## REVISED RESPONSE TO REQUEST FOR ADDITIONAL INFORMATION

### APR1400 Design Certification

RAI No.: 208-8245

SRP Section: 03.08.03 – Concrete and Steel Internal Structures of Steel or Concrete Containments

Figure 2. Line of Sight from Sparger

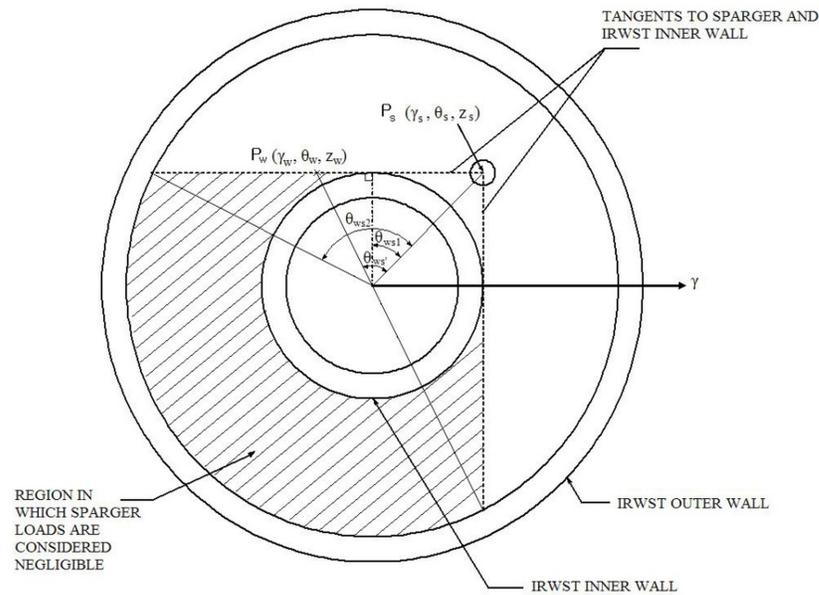
- a. How the pressure transient (including the steady state portion) for a single sparger activation was developed (a figure of this load over time should be provided).
- b. What cases of activation of the spargers may occur, i.e., one sparger alone, two spargers simultaneously, and/or some lag between the two activations.

- c. How the total pressure transients on the walls and floor were developed based on the cases identified in item (b) above (a figure showing the pressure distributions on the walls and floor should be provided).
- d. How the dynamic impact factor, discussed in DCD Section 3.8A.1.4.3.1.3, was determined, and explain why applying this as a static load is considered conservative.

Using basic trigonometry, distance,  $r_{ws}$ , from the sparger center point  $P_s$  ( $r_s, \theta_s, z_s$ ) to the interested point  $P_w$  ( $r_w, \theta_w, z_w$ ) in Figure 2 is

Air bubble discharge loads from a particular sparger are considered to act only on the boundaries which can be "viewed" from the sparger bubble with direct line of sight as

illustrated in Figure 2. To find the shade area, angle  $\theta_{ws}$  on the line of the tangents to the sparger and inner wall can be expressed as

The shade regions between these two angles are not in direct line of sight of the depicted sparger discharge and, therefore, no load acts on these boundaries due to this sparger discharge.
